MIL-C-27505B (USAF)
AMENDMENT 2
20 Jul 83
SUPERSEDING
AMENDMENT 1
12 JULY 1973

MILITARY SPECIFICATION

CARTRIDGE, ENGINE STARTER MXU-4A/A

FIGURE 1. INTERIOR DIMENSIONS OF CARTRIDGE BREECH
7 of 7

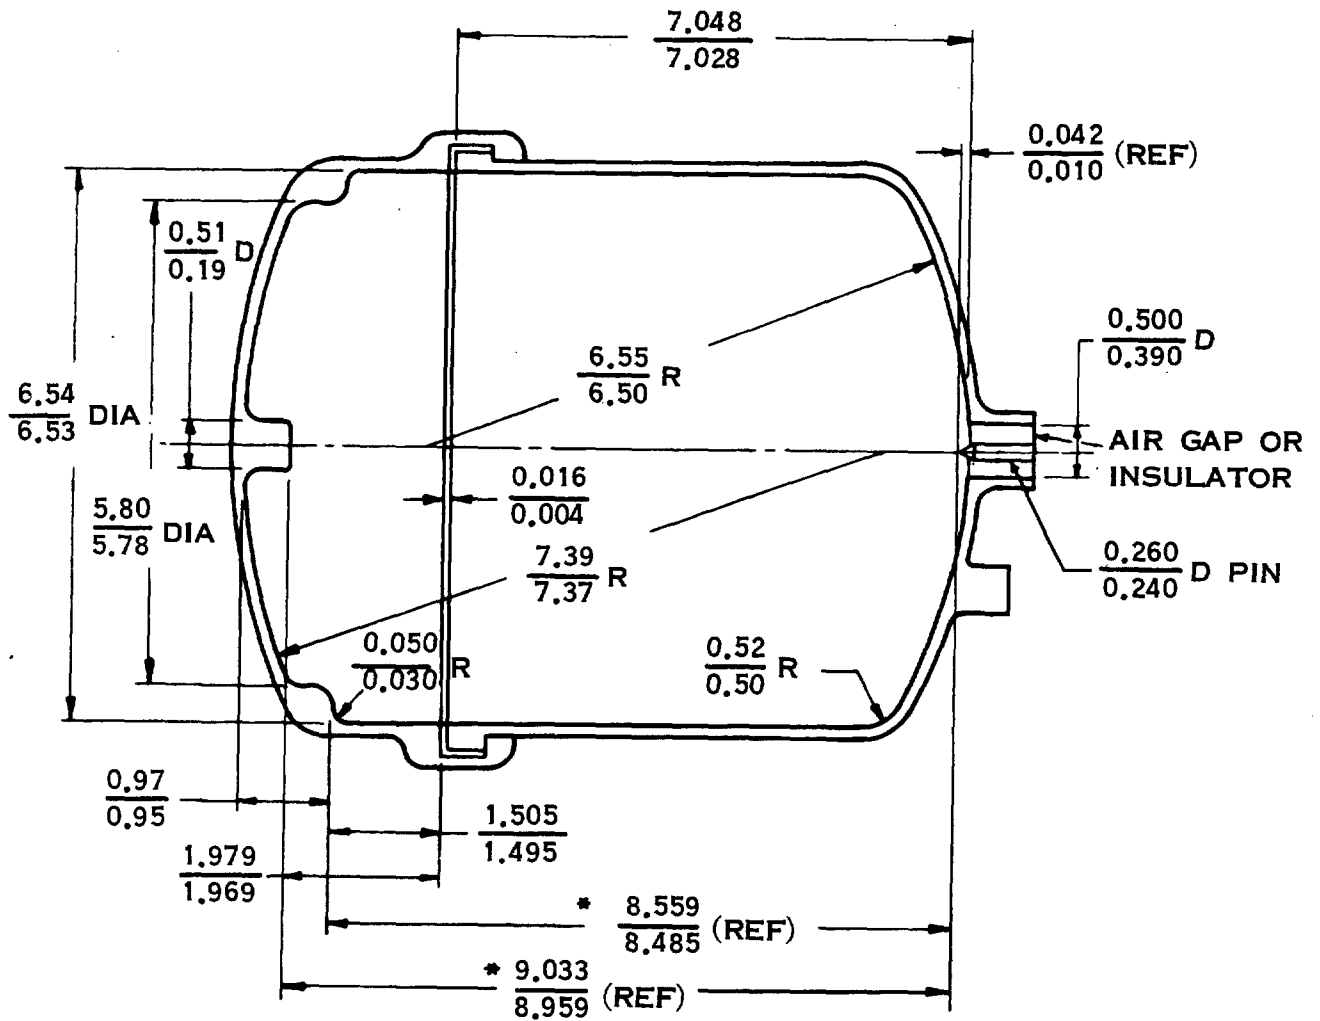
FIGURE 1: Delete and substitute the figure 1 attached hereto,

* EXTREME LIMITS OF TOLERANCE STACKUP
